R7 Network PTZ Dome Camera Firmware

Version: V5.6.0 Release Note (External)

(2019 - 03 - 22)

3.1.3 Configure Multicast Live View Address

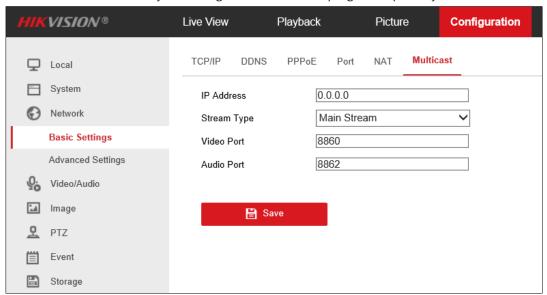
- Configure the multicast address and port on the configuration tab. Different channels and different streams can be configured with their own multicast ports.
- This feature can only be configured via the web plugin temporarily.

3.1.8 Default Protocol parameters are redefined

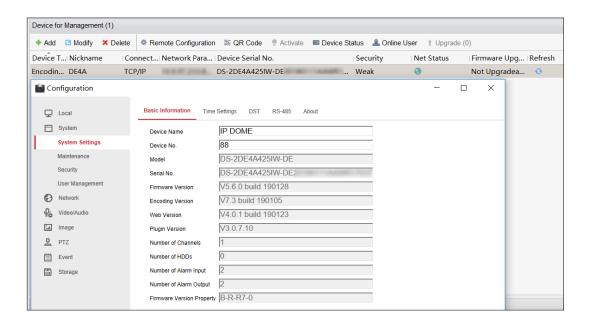
- HTTPS, WebSocket, SDK services
 - Enhanced SDK service is enabled by default. 'Restore' action keeps the parameters as before, while 'Default' would enable the enhanced SDK by default;
 - ONVIF service is not enabled by default, 'Restore' action keeps the parameters as before, while 'Default' would not enable ONVIF by default; websockets is not enabled by default, 'Restore' and 'Default' would not enable the websockets by default.
 - TLS1.1 and TLS1.2 are enabled by default, for both 'Restore' and 'Default' operations;
 - For old devices upgrading to 5.6.0, maintain the original parameters: if the SDKS did not exist before, the new version is not enabled by default;
 - For the new cameras of 5.6.0, the SDKS (SDK over TLS) service is enabled by default.

3.1.15 Upgrade specific SD cards

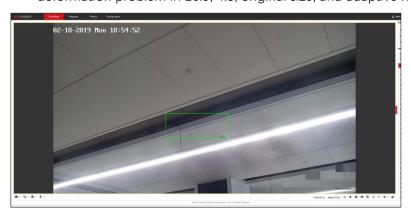
- Specific SD cards could be upgraded through PTZ devices;
- This upgrade is applicable to Hikvision MicroSD card products: L2 series (16G, 32G, 64G, 128G), and H1 series (32G, 64G).

3.1.19 Add Alarm output delay option

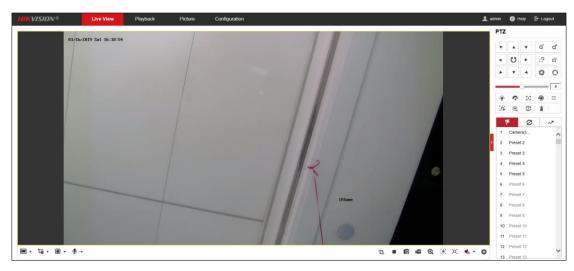
- Add alarm output delay configuration, 5s/10s... were available before, in order to adapt to different application environments, the configuration of 1s is added;
- Alarm output delay can be configured as manual, 1s, 5s, 10s, 30s, 1 min, 2 mins, 5 mins, 10 mins.

3.2.1 Security of Wi-Fi devices is enhanced

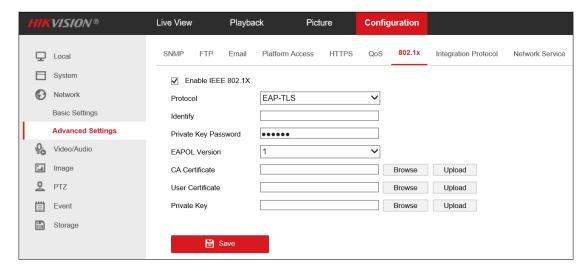
- Wi-Fi component library is update. Wi-Fi could be set to on/off; default is on.

3.2.3 Add 802.1X authentication (EAP-TLS, EAP-LEAP)

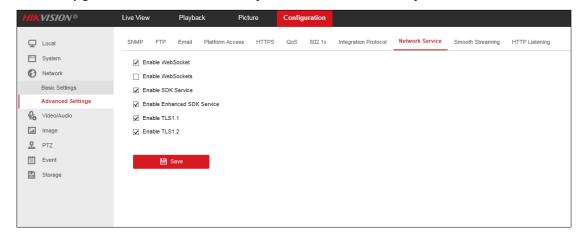
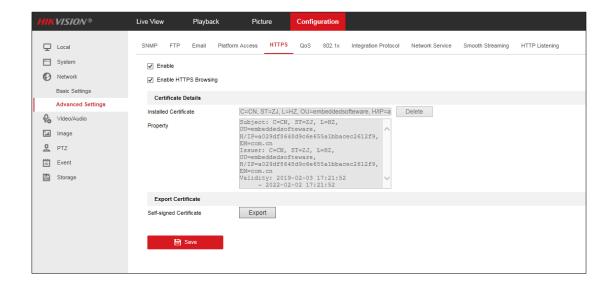
- 2 protocols of 802.1X is added: EAP-TLS, EAP-LEAP, and the certificate is not restored after 'Restore':

- Add SDK over TLS protocol port configuration. The default port is 8443, with the configuration range 2000~65535. It cannot be duplicated with other protocol ports. The name is an enhanced service port. For the SDK protocol that defaults to port 8000, the logic remains the same;

- SDK over TLS service could be enabled/disabled, and the default SDK over TLS service is enabled (for the 'Default' operation), and the name is to enabling the enhanced SDK service. SDK service could also be enabled/disabled, and the name is enabling the SDK service. 'Restore' maintains the parameters as before;

- When the service is provided through the SDK over TLS, the stream is sent by RTSP;
- The self-signed root certificate could be exported;
- A self-signed certificate is generated on the first boot, and the SDK over TLS service is started via a self-signed certificate. Certificate and https could be reused, without additional SDK over TLS certificate management;

- Device has a self-signed certificate before delivery. At this time, SDK over TLS is enable by default.
- A warning is added when Device certificate is deleted for Websockets, https, and SDK over TLS.
